NEDO-33004-A

LICENSING TOPICAL REPORT

CONSTANT PRESSURE POWER UPRATE

By letter dated February 6, 2003, which incorporates Errata and Addenda 1, GE Nuclear Energy (GENE) provided a revised Constant Pressure Power Uprate (CPPU) licensing topical report (LTR) documenting the basis for the approach to be used for GE-prepared BWR constant pressure power uprate safety analysis reports. The revision addresses NRC's concerns stated in a letter dated August 12, 2002, withdrawing our safety evaluation (SE) approving the use of the CLTR. The NRC has considered this request and with the exception of the proposed elimination of large transient testing, has approved the use of this LTR. The staff intends to issue a supplement to the SE when the large transient testing guidance is available.

Figure 1-1. Typical CPPU-Based Power Uprate Power/Flow Map

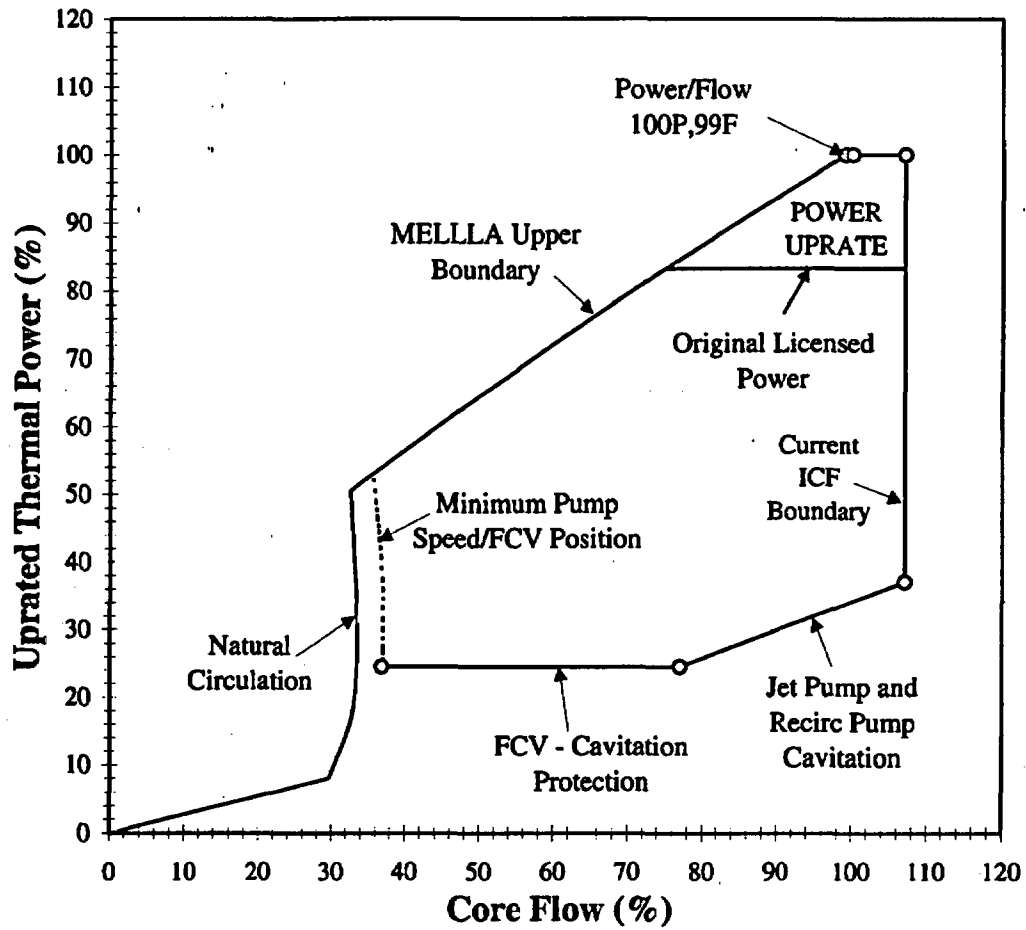
The CPPU power/flow operating map is an extension of the current MELLLA or MEOD operating map. Therefore, the CPPU LTR and the safety evaluation are applicable only to plants that are currently licensed to operate with the MELLLA or the MEOD operational margin improvement option. A typical power/flow map showing the CPPU change in allowable operating conditions is shown on Figure 1-1 of the LTR.
